**CITY OF NEWTON, MASSACHUSETTS
PURCHASING DEPARTMENT
purchasing@newtonma.gov
Fax (617) 796-1227**

**ADDENDUM #2
INVITATION FOR BID #21-09**

WABAN HILL RESERVIOR IMPROVEMENTS
--

CITY OF NEWTON NEWTON, MASSACHUSETTS		WABAN HILL RESERVOIR REHABILITATION		Drawn By: MSB Designed By: RSP Checked By: FBH Approved By: KLG
CENTRAL CORE DEMOLITION PLAN		ADDENDUM NO. 2		THIS DOCUMENT IS THE PROPERTY OF TATA & HOWARD, INC. AND ITS CLIENT. REPRODUCTION OR MODIFICATION WITHOUT WRITTEN CONSENT IS PROHIBITED.
1	10/6/20			
Rev.	Date	Description		
TATA & HOWARD				
T&H NO.: 4589				
DATE: OCTOBER 2020				
SCALE: AS NOTED				
D-1

DEMOLITION PLAN
SCALE: 3/8" = 1'-0"

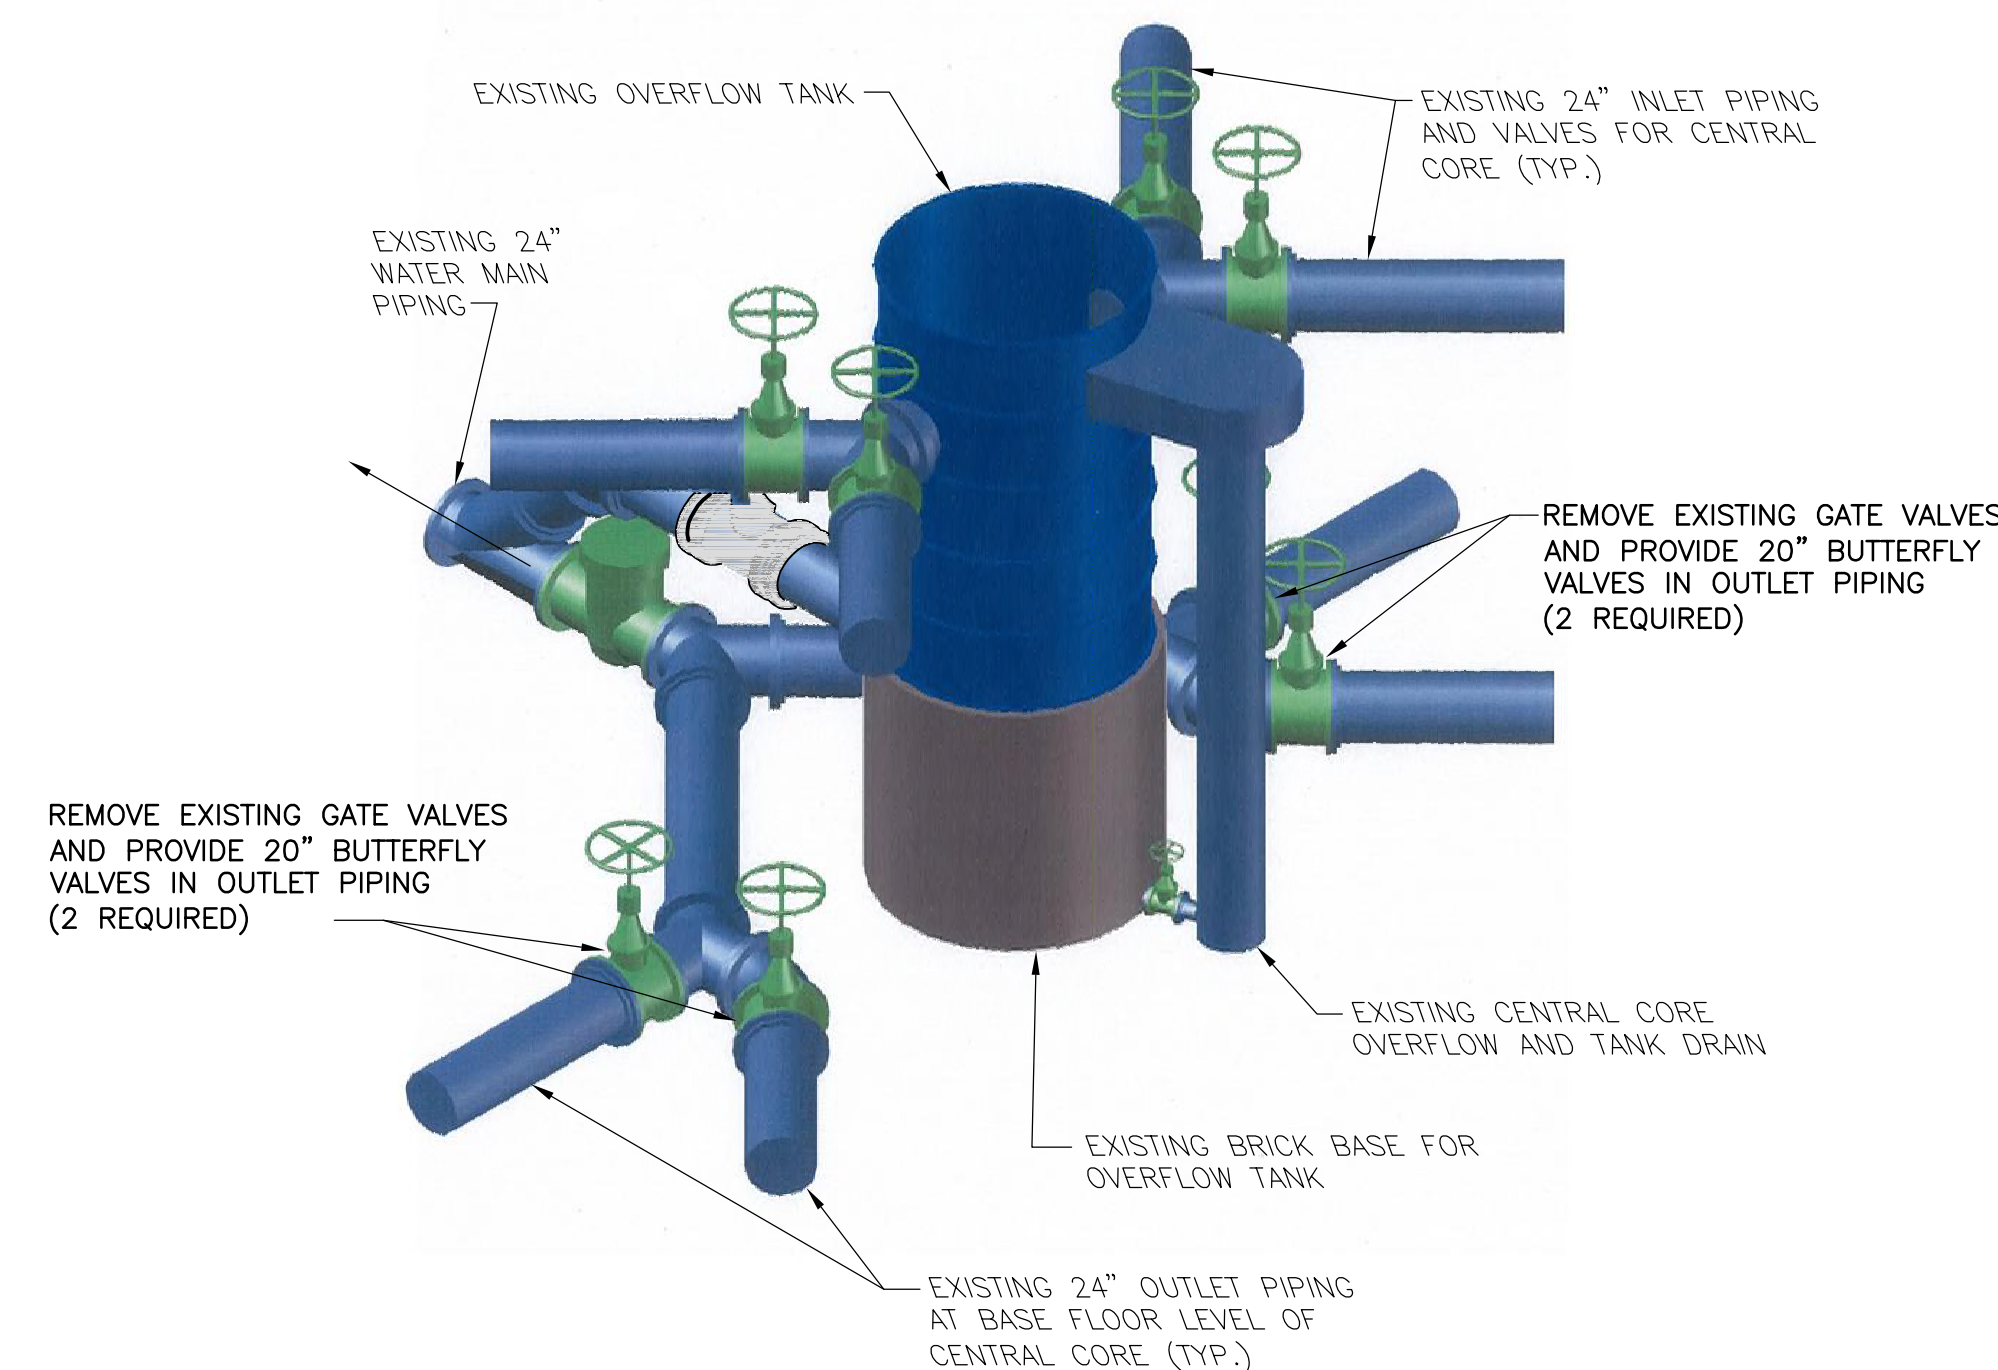
1. Reference Sheet D-1. Delete in its entirety and replace with attached Revised Sheet D-1.
2. Reference Sheet M-1. Delete in its entirety and replace with attached Revised Sheet M-1.
3. Reference Sheet A-1, New Construction Notes. Delete New Construction Note #2 and replace with the following:

EXISTING 24-INCH OUTLET PIPING TO BE DEMOLISHED UP TO AND INCLUDING FLANGE NEAR TANK WALLS. EXISTING 24-INCH OUTLET PIPING BEYOND FLANGES INTO TANK TO REMAIN

REMOVE AND PROPERLY DISPOSE OF EXISTING PLYWOOD COVERS ON CENTRAL CORE TANK AND OVERFLOW

EXISTING 24-INCH OUTLET PIPING TO BE DEMOLISHED UP TO AND INCLUDING FLANGE NEAR TANK WALLS. EXISTING 24-INCH OUTLET PIPING BEYOND FLANGES INTO TANK TO REMAIN

REMOVE EXISTING CHECK VALVE AT FITTING BELL TO ACCOMMODATE NEW PIPING AS SHOWN ON M-1
